**AGENDA
PLANNING COMMISSION
116 WEST NEEDLES
BIXBY, OKLAHOMA
November 16, 2015 6:00 PM**

2. **PUD 92 – “Stone River Place” – Marc P. Bullock.** Public Hearing, discussion, and consideration of a rezoning request for approval of a Planned Unit Development (PUD) for approximately 1.172 acres in part of the NE/4 NW/4 of Section 02, T17N, R13E.
Property Located: 6900-block of E. 121st St. S.

4. **PUD 78 – “Willow Creek” – Major Amendment # 1 – Rosenbaum Consulting, LLC for Willow Creek Development, LLC.** Public Hearing, discussion, and consideration of a rezoning request for approval of Major Amendment # 1 to Planned Unit Development (PUD) # 78 for approximately 43.965 acres, all of *Willow Creek Estates*, with underlying zoning RS-3 Residential Single-Family District and RM-3 Residential Multi-Family District, which amendment proposes to allow off-street parking to be located off the subject property and within the Public street right-of-way (cf. Zoning Code / City Code Section 11-10-2.D), to remove the 7.5’ minimum width parking lot setback and landscaped strip requirements (cf. Zoning Code / City Code Section 11-10-3.B Table 1 and 11-12-3.A.2), and make certain other amendments.

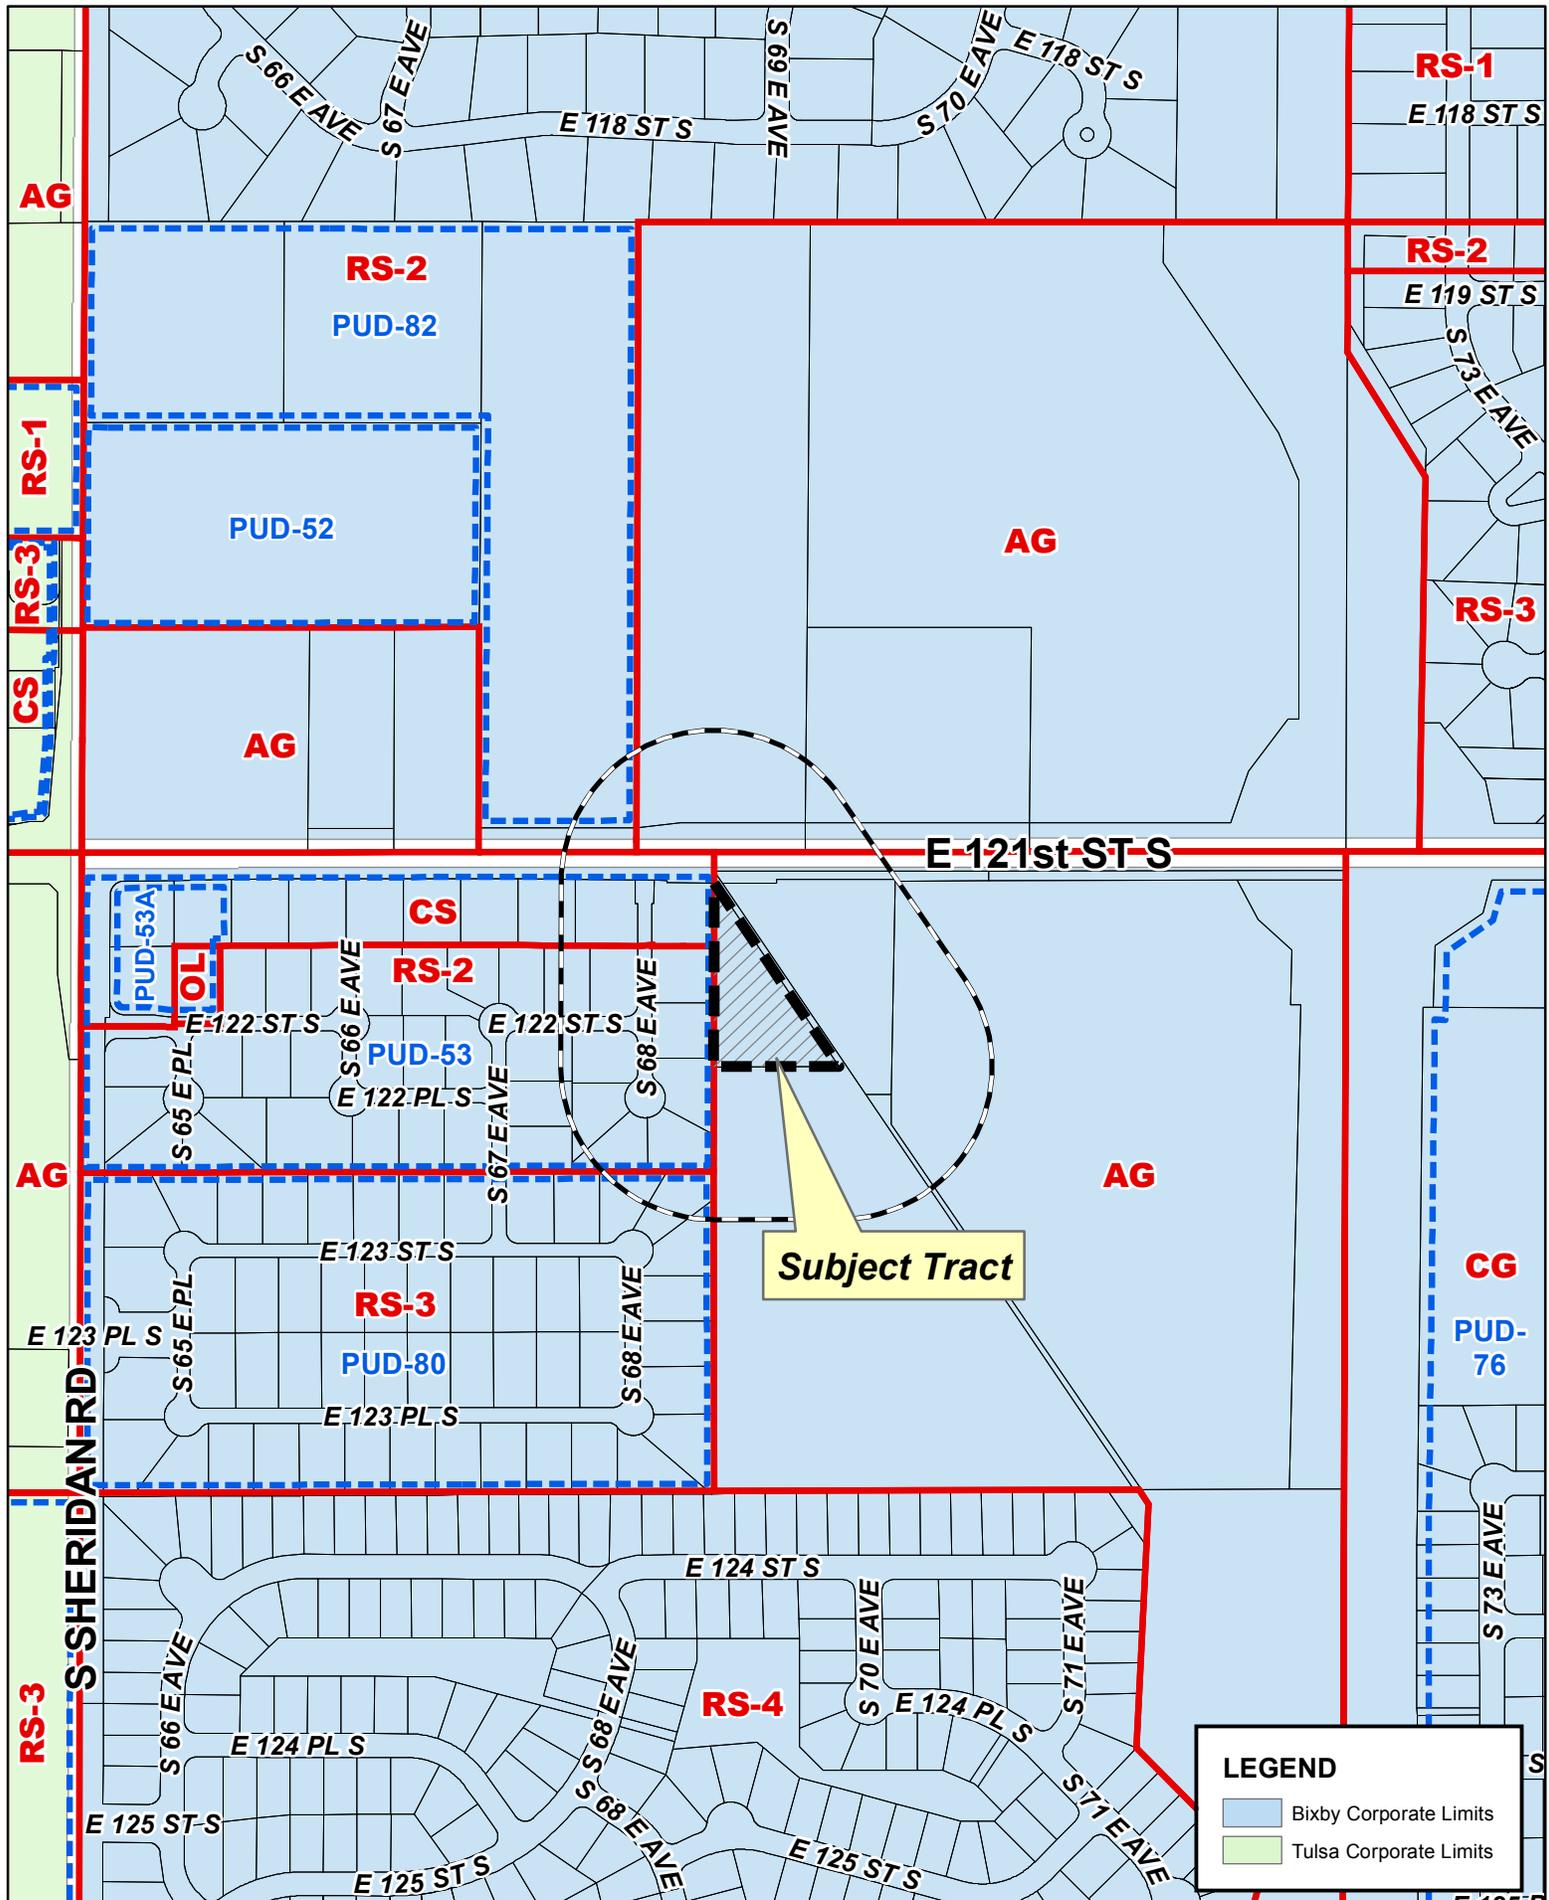
40. Exhibit B: Please relocate access gate to south end of “hammerhead” turnaround as per Fire Marshal recommendation at the TAC meeting or otherwise address appropriately. Discuss whether a second gate would be required for the east-west portion of the maintenance drive.
41. Exhibit B: Please clarify dashed, circular linetype and jointed/punctuated solid linetype south of the southwest lot corner.
